Power4Georgians' Responses to Public Comments
Regarding the Case-by-Case Maximum Achievable Control Technology Analysis

This document contains Power4Georgians' responses to the comments raised by Greenlaw and the Southern Environmental Law Center in their October 27, 2009 letter regarding the Environmental Protection Division's (EPD) and Power4Georgians' case-by-case maximum achievable control technology (MACT) analysis for Plant Washington. Power4Georgians notes that many of the issues raised by the Commenters have previously been addressed in materials submitted to EPD over the past several years, and thus incorporates those materials to the extent they contain relevant information.

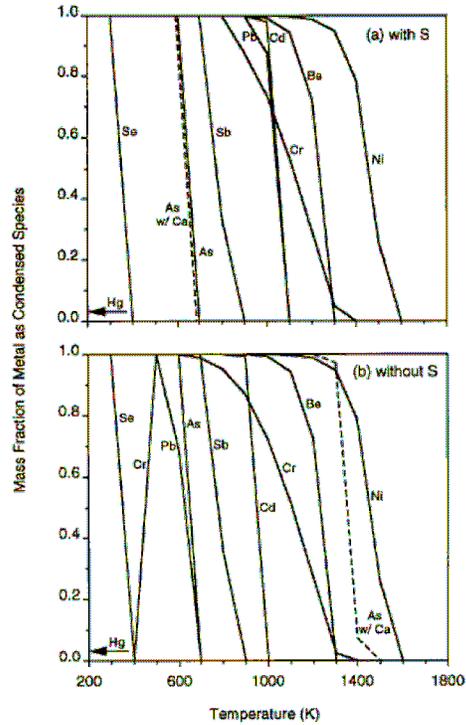
Commenters contend that metal HAPs, in particular selenium, arsenic, and chromium, should be regulated separately because these elements exist primarily in the vapor phase and would not be effectively captured by a particulate control device. The references cited by Commenters, however, do not support this contention (e.g., Commenters' Ex. 2, Ex. 4). The following figure is taken from Page 2 of Commenters' Ex. 4, titled *Toxic Emissions by Utility Coal Fired Boilers – Trace Metals in Combustion Systems (2008)*.

As can be seen in the referenced figure, chromium (Cr) is considered both a Class I and Class II element, while arsenic (As) is considered a Class II element and selenium (Se) is considered both a Class II and Class III element. Of greatest concern would be those elements considered Class III, or with little tendency to condense from the vapor phase. Therefore, Commenters' claims regarding arsenic, selenium, and chromium are unsupported by the provided documentation.

The temperature of the exhaust gas stream and the presence of other compounds (e.g., sulfur) in the exhaust gas will determine the condensation of non-mercury metal HAPs, including metal species such as oxides. These issues were discussed and evaluated in Commenters' Ex. 2, titled *Trace metal transformation mechanisms during coal combustion (1993)*. The following figures are Figure 3 (p. 179) and Figure 4 (p. 184) of that document.

As can be seen from the referenced figures, metal species evaluated, including arsenic and chromium but with the exception of selenium, are not in a vapor phase at temperatures less than 500 °K, or approximately 440 °F. Based on data provided by a design engineering company, the estimated flue gas exhaust temperature at the baghouse for Plant Washington will be between 310 °F to 350 °F, or 425 °K to 450 °K. Therefore, the information provided in Commenters' Ex. 1 suggests that the non-mercury metal HAPs, including both arsenic and chromium (but not selenium), should not be in the vapor phase by the time the exhaust gas reaches Plant Washington's fabric filter baghouse.

Fig. 7. The collection efficiencies of trace elements in different particulate size fractions.

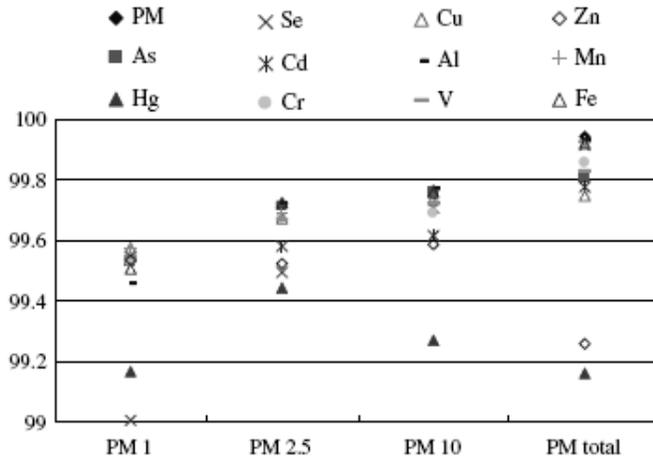
Comment: The particulate control device - a fabric filter baghouse, does not indiscriminately capture all HAP metal emissions because these HAPs are concentrated in the smallest particles, which are not efficiently collected by the proposed particulate collection device or because they are present in condensables. (Ex. 1, Ex. 2, Ex. 6, Ex. 7A, Ex. 7B, Ex. 8, Ex. 9, Ex. 10, Ex. 11, Ex. 12, Ex. 13, Ex. 14, Ex. 15, Ex. 16, Ex. 17)

Response: Commenters' claim that Plant Washington's baghouse will not indiscriminately capture all HAP metal emissions is not supported by Commenters' own references. For example, Commenters' Ex. 5, titled Fine particle and trace element emissions from an anthracite coal-fired power plant equipped with a bag-house in China

(2007), indicates that collection efficiencies of the particulate phase of trace elements are captured at greater than 99% down to the 1 micron range. The following is Figure 7 from Commenters' Ex. 5.
